SALEM NUCLEAR GENERATING STATION, UNIT NO. 1

AMENDMENT TO FACILITY OPERATING LICENSE

Amendment No. 52
License No. DPR-70

SAFETY EVALUATION BY THE OFFICE OF NUCLEAR REACTOR REGULATION
RELATED TO AMENDMENT NO. 52 TO FACILITY OPERATING LICENSE NO. DPR-70
AND AMENDMENT NO. 20 TO FACILITY OPERATING LICENSE NO. DPR-75

FIGURE 2.1-1 REACTOR CORE SAFETY LIMIT - FOUR LOOPS IN OPERATION

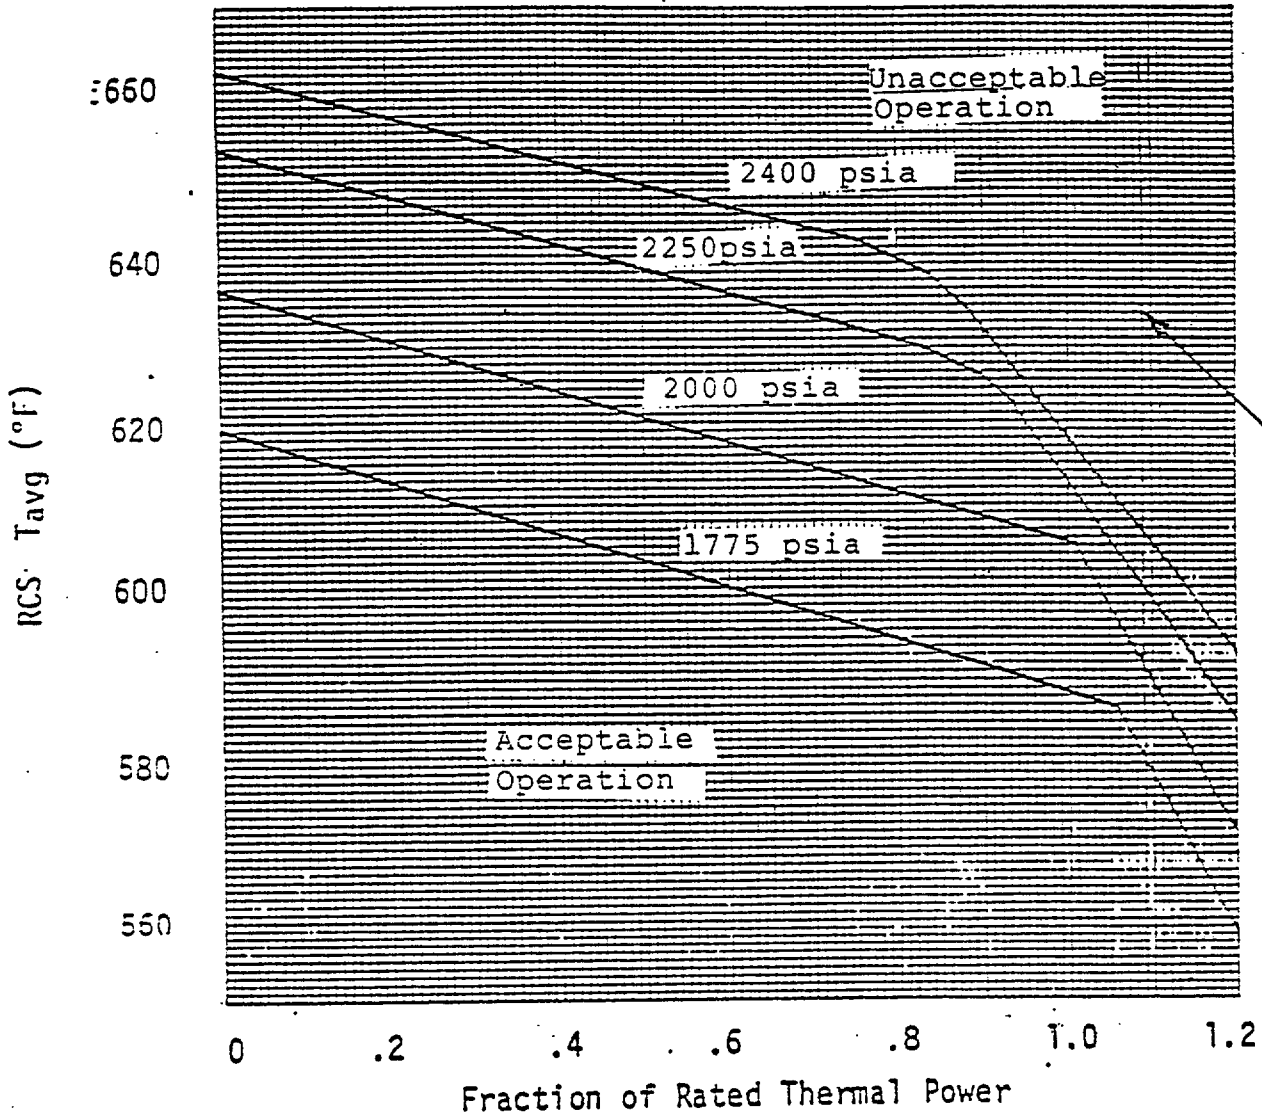
The curves are based on an enthalpy hot channel factor, $F_{\Delta H}^N$, of 1.55 and a reference cosine with a peak of 1.55 for axial power shape. An allowance is included for an increase in $F_{\Delta H}^N$ at reduced power based on the expression:

$$F_{\Delta H}^N = 1.55 [1 + 0.3 (1-P)]$$

Figure 3.2-3
RCS TOTAL FLOWRATE VERSUS R - FOUR LOOPS
IN OPERATION

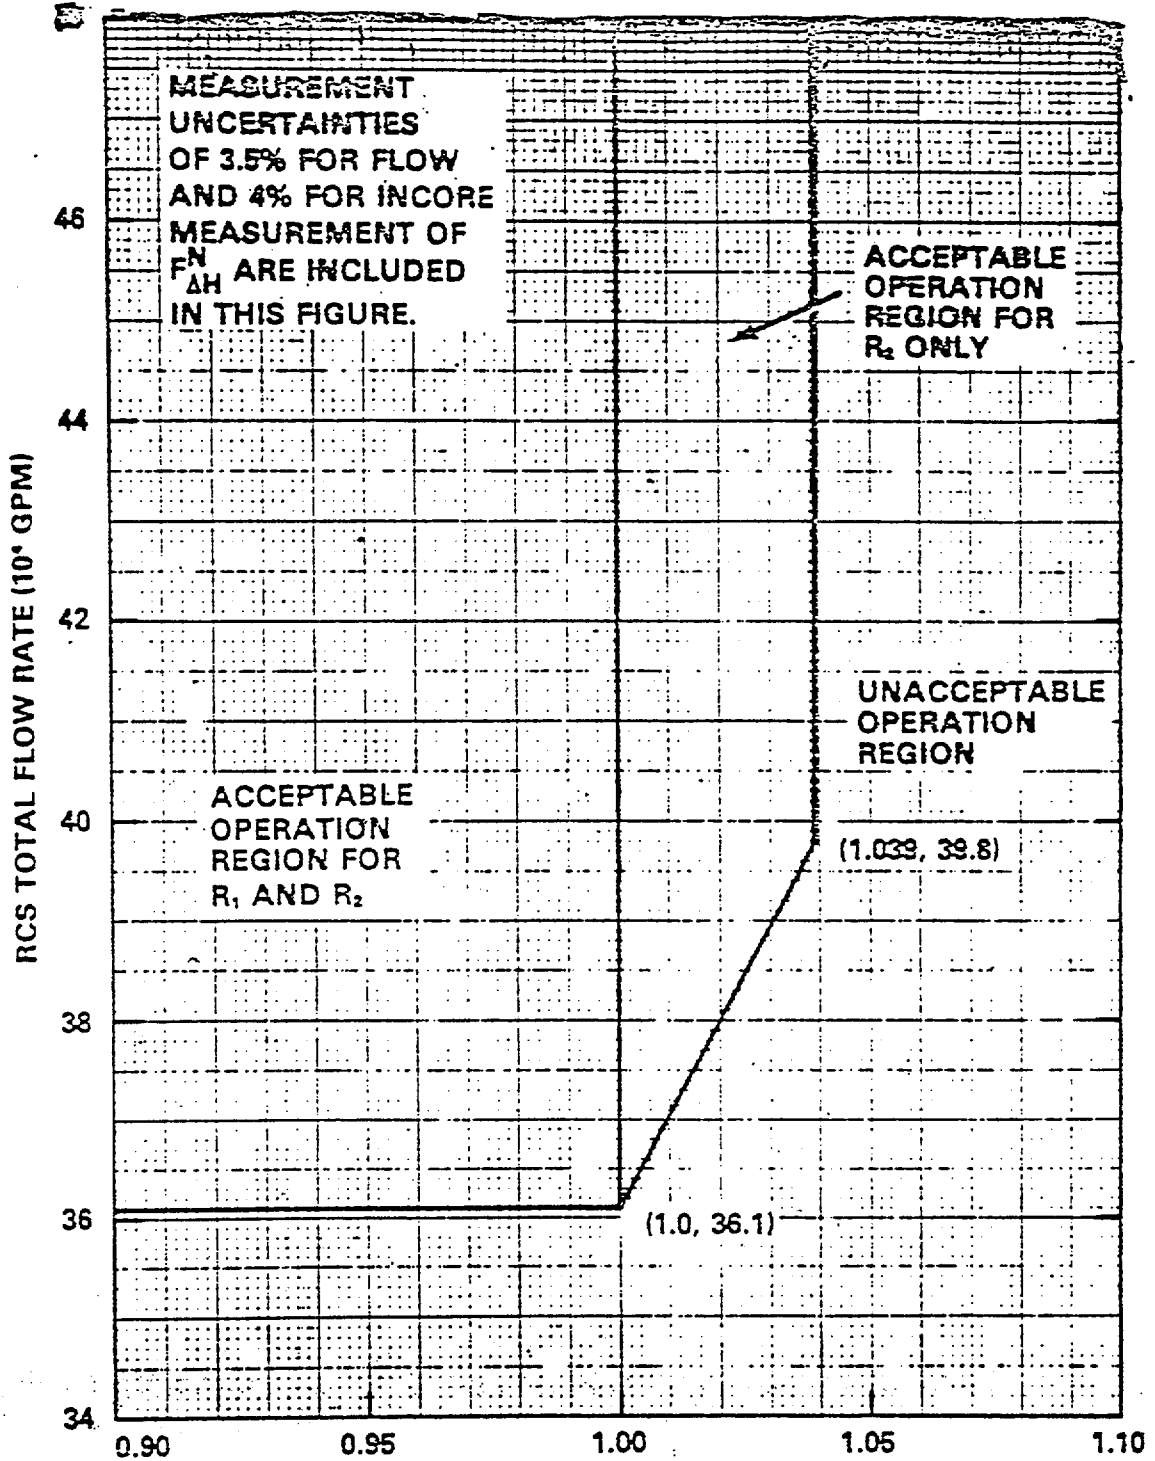
$$a. \quad R_1 = \frac{F_{\Delta H}^N}{1.49 [1.0 + 0.3 (1.0 - P)]}$$

$$R_1 = \frac{F_{\Delta H}^N}{1.49} [1.0 + 0.3(1.0 - P)]$$

$$R_2 = R_1 / [1 - RBP(BU)]$$

FIGURE 2.1-1 REACTOR CORE SAFETY LIMIT - FOUR LOOPS IN OPERATION

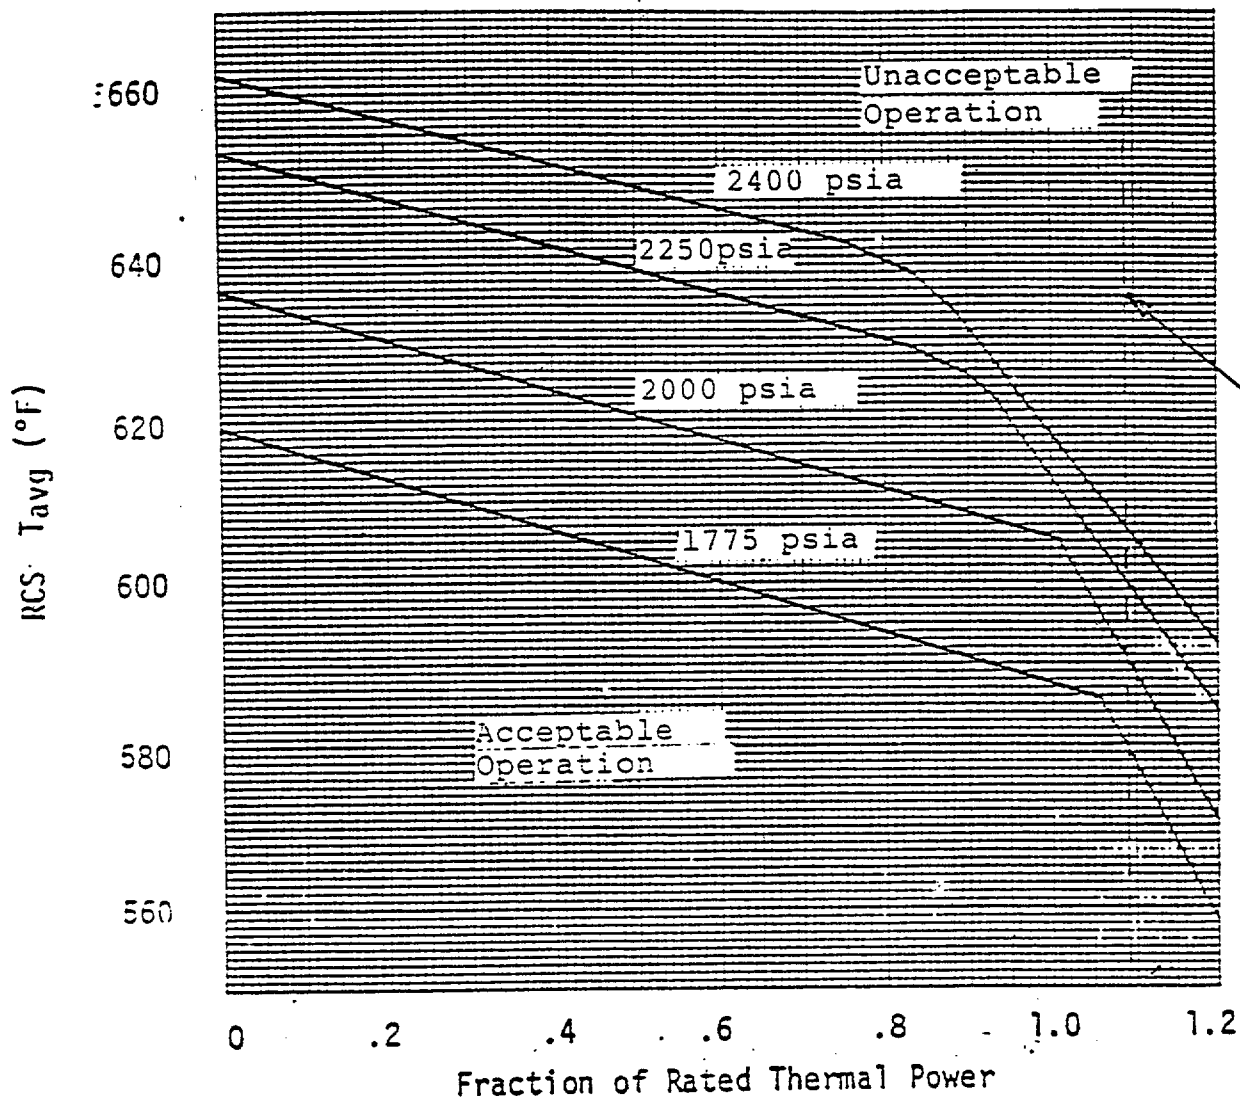
The curves are based on an enthalpy hot channel factor, $F_{\Delta H}^N$, of 1.55 and a reference cosine with a peak of 1.55 for axial power shape. An allowance is included for an increase in $F_{\Delta H}^N$ at reduced power based on the expression:

$$F_{\Delta H}^N = 1.55 [1 + 0.3(1-P)]$$
